Report on Spurwing Dam, Letata, Dullstroom

Cutwater Farms (Pty) Ltd

Prepared by Nicholas Papenfus

April 2004

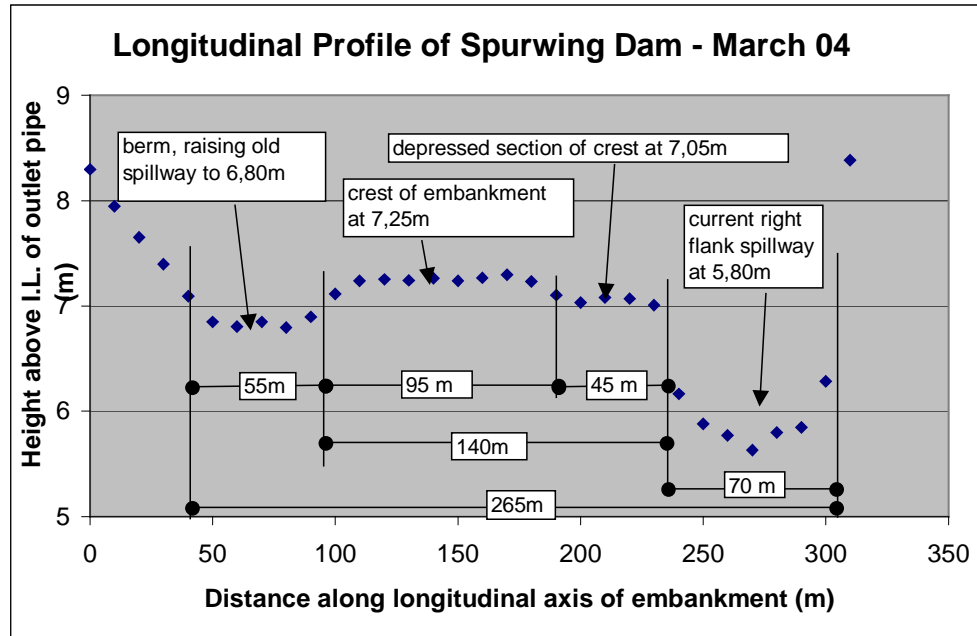
It is evident from figure 1 that the crest of the embankment is virtually horizontal. This is generally an indication of an embankment that was well compacted during the construction stage. All embankment dams consolidate (compact under their own weight with time) to a greater or lesser extent, and clearly consolidation will be greater where the embankment is highest. So for an embankment to still be virtually horizontal and not V shaped after 12 years implies that it was very well compacted at the construction stage. A well compacted embankment generally has good shear strength and hence the various forms of shear failure that are possible are most unlikely even for the increased forces associated with a possible overtopping event (to be discussed later). It also means that it will not erode as easily as would a poorly compacted embankment in the event of water flowing over the crest and down the embankment during overtopping.

As indicated in figures 1 and 3, there is a portion of the crest, approximately 45m in length, that requires additional material to raise it by approximately 0,2m, so that it is at the same elevation as the rest of the crest. This will enable the crest to act as an emergency spillway, for floods exceeding 1 in 100 years. A tolerance of plus/minus 25mm is acceptable for the final elevation of the crest. Once again this is a simple process of clearing existing vegetation, bringing in the correct ground, spreading over the existing crest, and compacting with relatively small roller vibrators.

The crest of the embankment has a few high and low spots (over and above what is mentioned in 7.4), as may be discerned from figure 1. This will require some trimming and filling in a few places. A tolerance of plus/minus 25mm is acceptable.

Figure 3 – Schematic Plan of Spurwing Dam indicating proposed scheme of work (7.1 to 7.6).

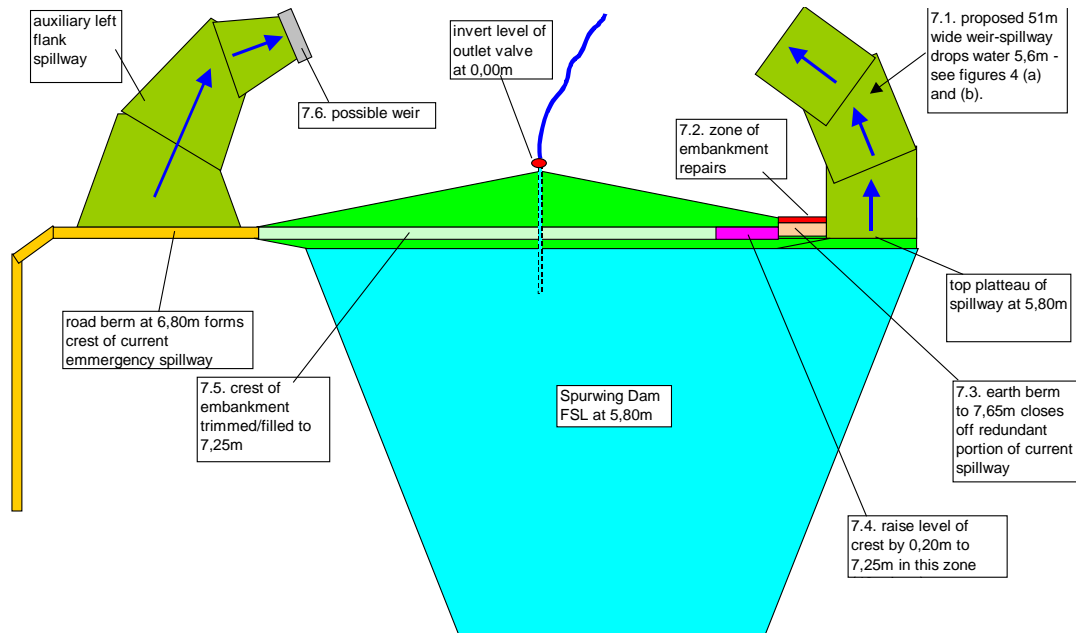
Six areas requiring attention have been addressed in the preliminary design. These may be located in figure 3 and are fully described in 7.1 through 7.6. The preliminary design is further supported by figures 4 through 7.

Once the repairs in 7.2 have been completed, an earth berm can be constructed on top of the existing spillway, starting at the point where it currently begins to descend, through to the gabion structure shown in figure 3. The berm will therefore be about 19m long, 3m wide at the top, and 1,85m high. This will not require vast quantities of ground, which can be sourced from the excavated channel of the re-engineered right hand

Consideration should also be given to constructing a weir in the auxiliary spillway as indicated in figure 3, even if it is to remain as the auxiliary spillway. At the point indicated the spillway descends steeply, and a weir (either gabion, or random-rock-masonry) that is designed to dissipate the energy would virtually eliminate maintenance. Note that this spillway will only start to function the moment the flow exceeds $86\text{m}^3/\text{s}$, i.e. above the 1 in 20 year RI flood. However, it may be decided that the cheaper option is to simply do periodic repairs, since generally the proposed weir-spillway on the right flank will cater for most events.

Figure 4 (a) - Section through longitudinal profile of weir-spillway showing where the various changes in elevation are likely to occur. Background structures are not shown.

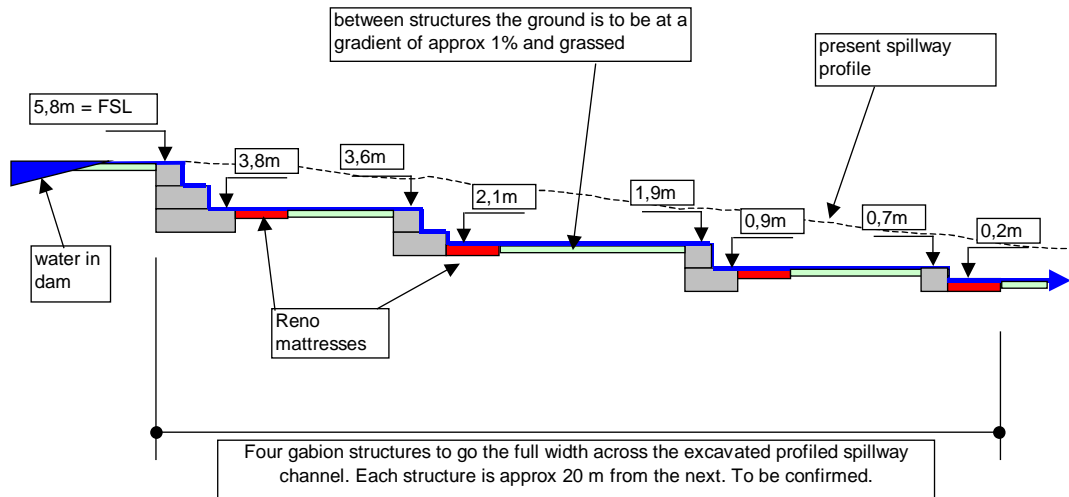
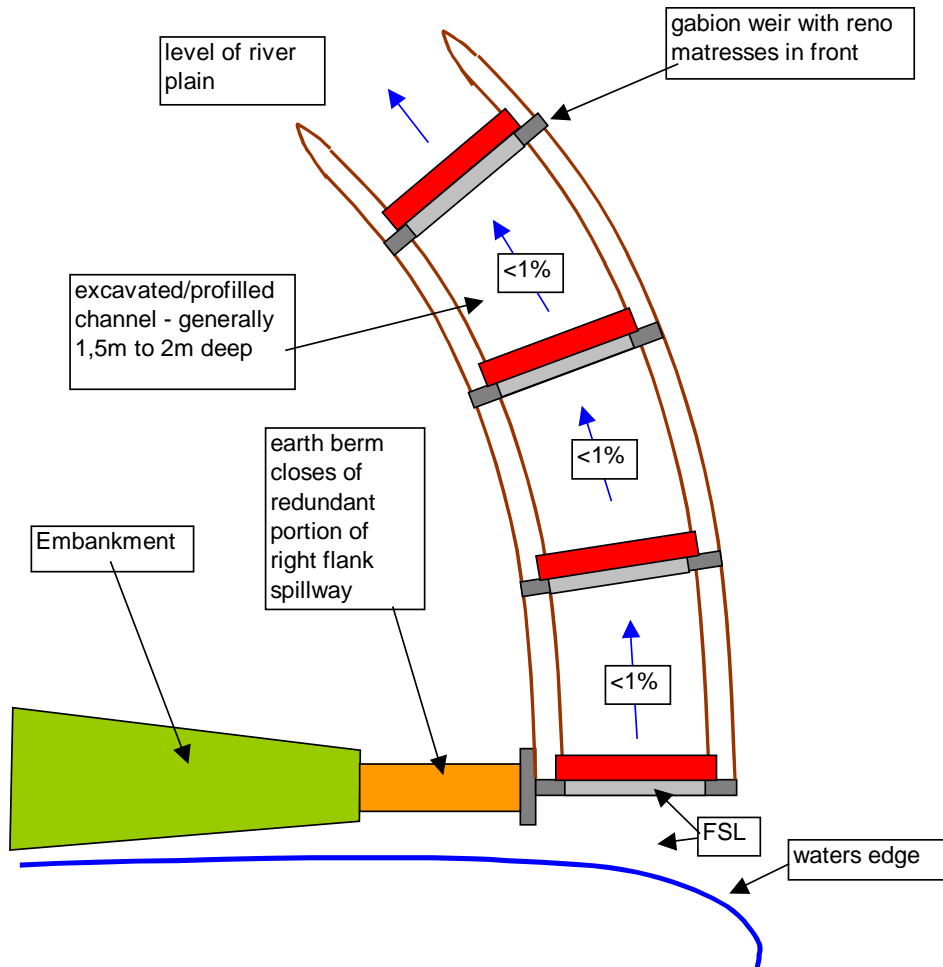
In section 5 a case for a 51m wide weir-spillway was made to serve as a means of conveying storm water around the dam. In this process the energy of the water is dissipated by lowering it 5,6m from the elevation of 5,80m (FSL) to a safe 0,20m via four weirs (see figure 4(a)) strategically positioned in an excavated/profiled channel (see figure 4(b)). All levels are referenced to the invert level of the outlet valve at 0,00m. Between the weirs the excavated channel will vary in depth from approximately 1,5m to 2,5m, and have a gradient not exceeding 1%. The total length of the spillway is expected to be of the order of 60m, and the weirs are spaced approximate 20m apart.

The cost of a 51m wide spillway that effectively has four step-down weirs (see figure 4 (a) and 4 (b)) and has an associated excavated channel that is approximately 60m long, may prove to be too costly.
